Final EIR Comments and Responses to Comments

Dalidio/San Luis Marketplace Annexation and Development Project Final EIR

FINAL EIR COMMENTS and RESPONSES

Figure 4.1-3
City of San Luis Obispo

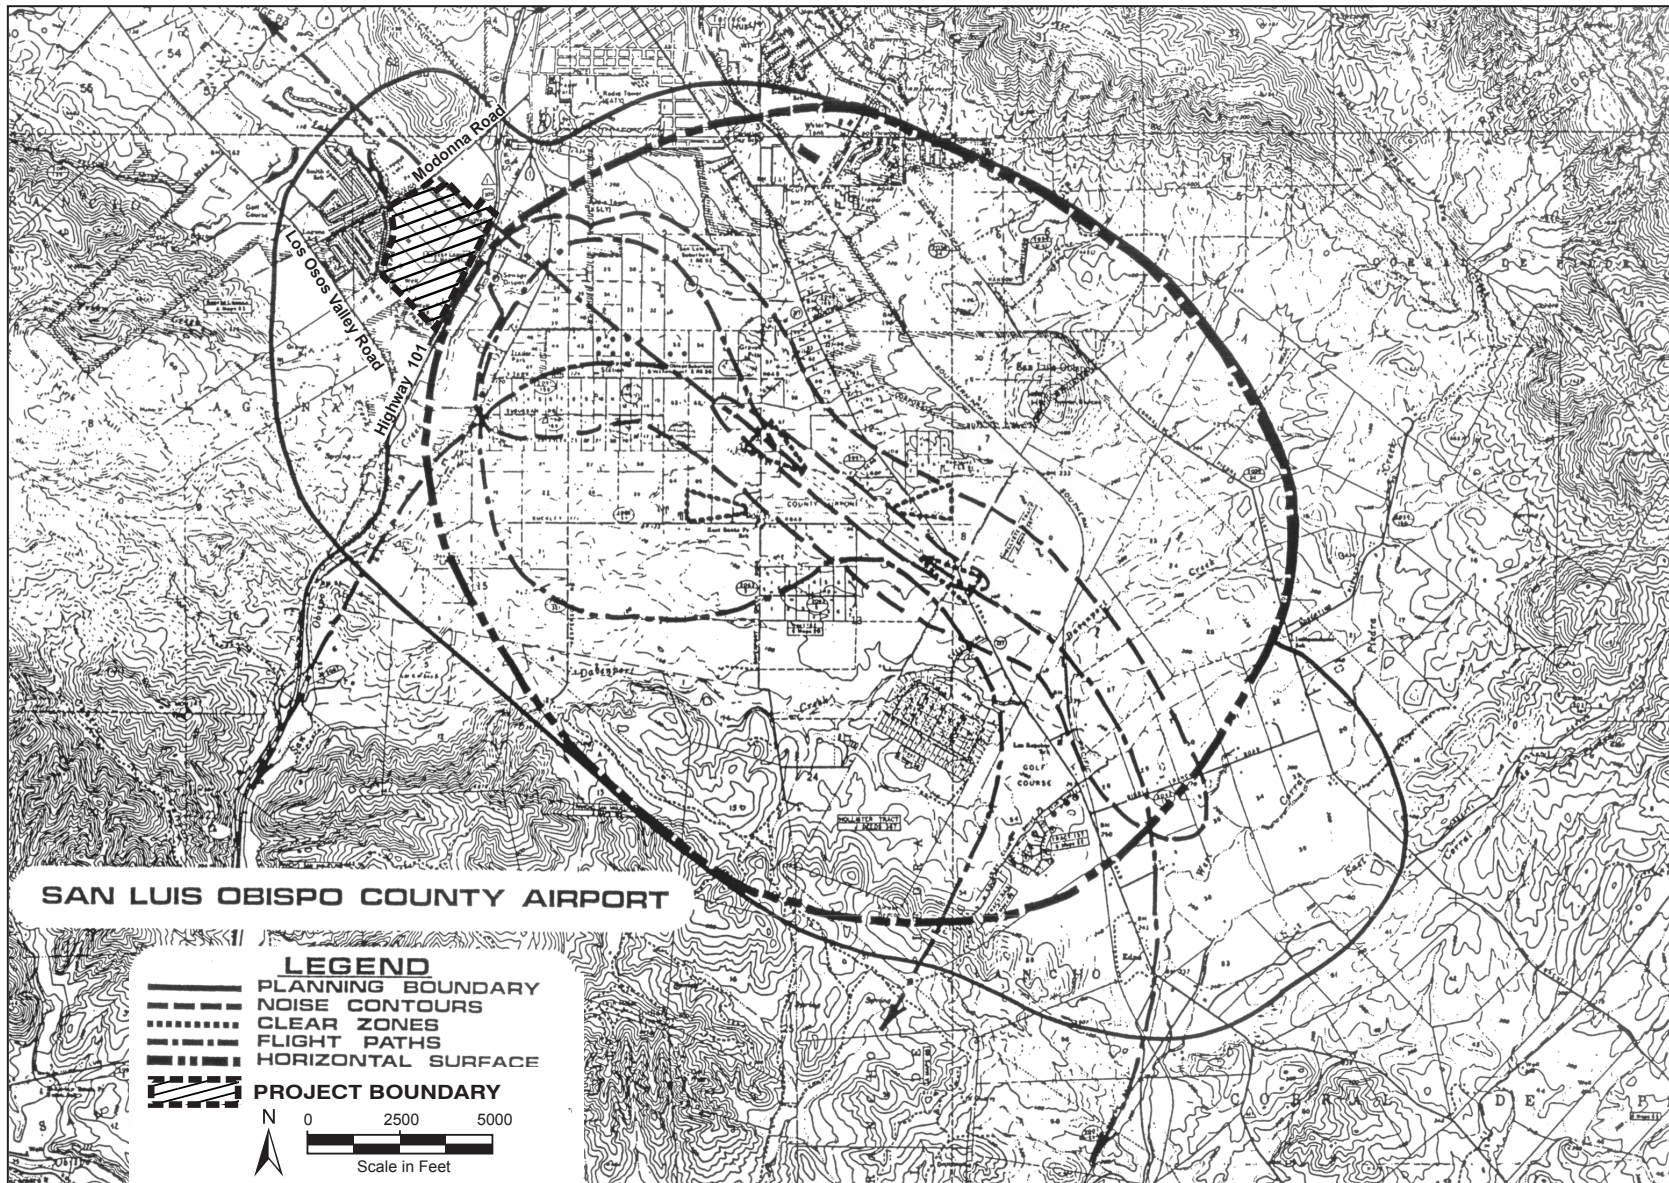
(Comment PC-55) Section 4.1 has been revised to include the following figure: “San Luis Obispo County Airport Hazards”.

Figure 1. Existing conditions hydrograph for San Luis Obispo Creek at its confluence with Prefumo Creek.

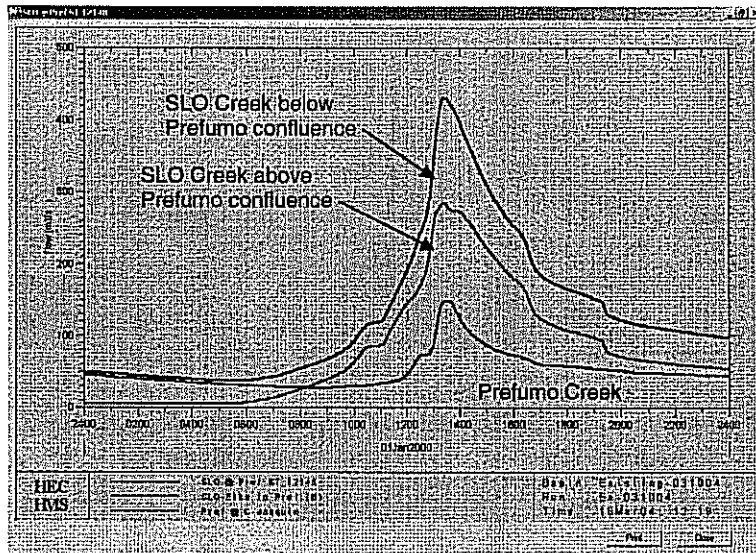
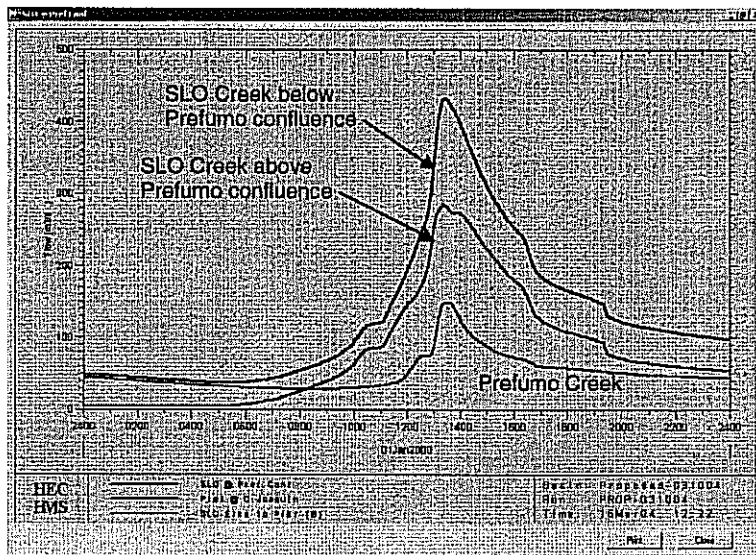
Below are the hydrographs for San Luis Obispo Creek at its confluence with Prefumo Creek. Figure 1 shows the existing conditions hydrograph; Figure 2 shows the proposed conditions hydrograph (accounting for increased impervious area and decreased floodplain storage). Previously published hydrographs did not include split flows over Highway 101 over existing conditions.

Thus, even after accounting for increased impervious surface area and loss of floodplain storage, discharge rates and water surface elevations do not significantly increase downstream of the proposed project site.
